Technical Note TN01A

Capel Street, Capel-le-Ferne

Project No. 16038-01

- 1.11 MA have therefore been instructed to prepare this Technical Note (**TN01**) in response to that representation.
- 1.12 The representation is substantive, however a number of the points made are repeated throughout the text, under separate sub-headings. **TN01** therefore attempts to address the most salient points that are considered relevant to the consideration of the planning application, addressing points where they are first referenced within the representation.

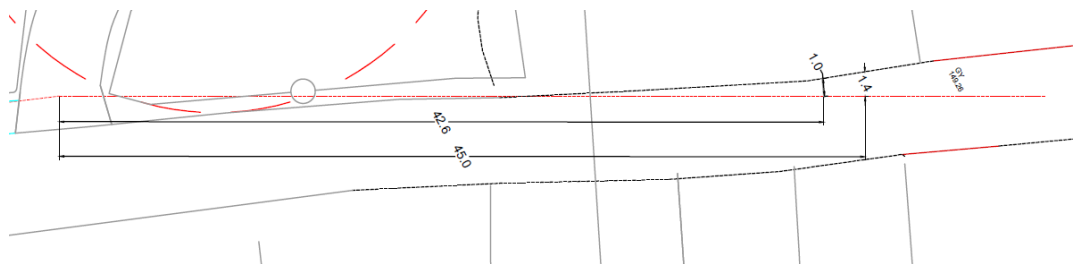
- 5.10 Reference is made later in the representation, at paragraph 2.6.2, to the potential traffic associated with the development between the hours of 15.00-16.00 being higher than between 17.00-18.00, indicated in the TRICS output. However, applying the TRICS based two-way trip rates to the proposed scale of development results in 20 anticipated vehicle

trips between 15.00-16.00, vs 19 vehicle trips between 17.00-18.00, which is not a material difference. Furthermore, this higher trip generation between 15.00-16.00 is likely influenced by traffic movements during the school run, which developing close to the existing primary school will clearly address by likely resulting in lower vehicle movements than assumed based on the TRICS outputs, with proximity to primary schools not adopted as a defining factor for the TRICS site selection. Subsequent sections of TN01, which address comments in relation to trip generation, identify that the proxy sites used to generate trip rates have an average walk distance of approximately 700m from the closest primary school, where as the subject site is within 150m walk distance from the adjacent primary school. On this basis it is not surprising that trip rates between 15.00-16.00 are comparable with those during a traditional PM peak and in reality are anticipated to be lower.
